Calibration and performance assessment of microgrid polarization cameras (Erratum)

[DOI: [10.1117/1.OE.58.8.089801](https://doi.org/10.1117/1.OE.58.8.089801)]

This article [*Opt. Eng.* 58, 082408 (2019), doi: [10.1117/1.OE.58.8.082408](https://doi.org/10.1117/1.OE.58.8.082408)] was originally published on 23 February 2019 with an error in Eq. 9. In the original manuscript, the equation for estimating the polarizer orientation angle was incorrect, causing incorrect angle estimates.

Fig. 1 Corrected version of Fig. (3) in the original manuscript: Spatial histogram results for the three cameras.

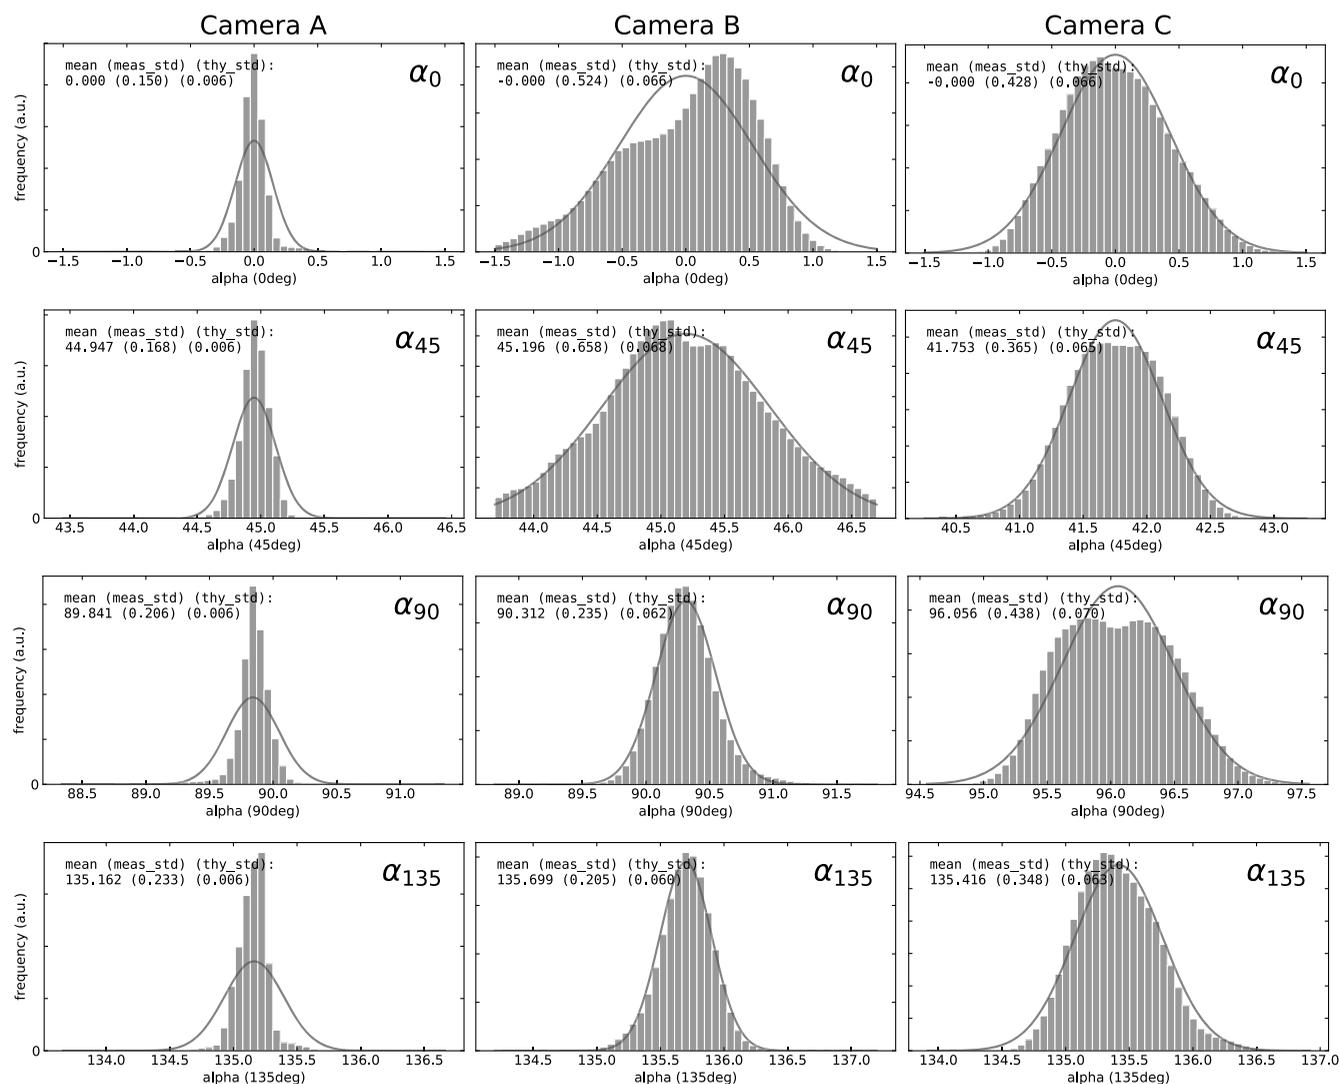
While this error has no effect on the variance formulas presented and does not alter the conclusions of the paper, it does affect the labeling in each of the figures and tables. Figures 1 and 2 here show corrected versions for two of the figures.

but should be

$$\hat{\alpha} = \frac{1}{2} \arctan[(g_{45} - g_{135}) / (g_0 - g_{90})].$$
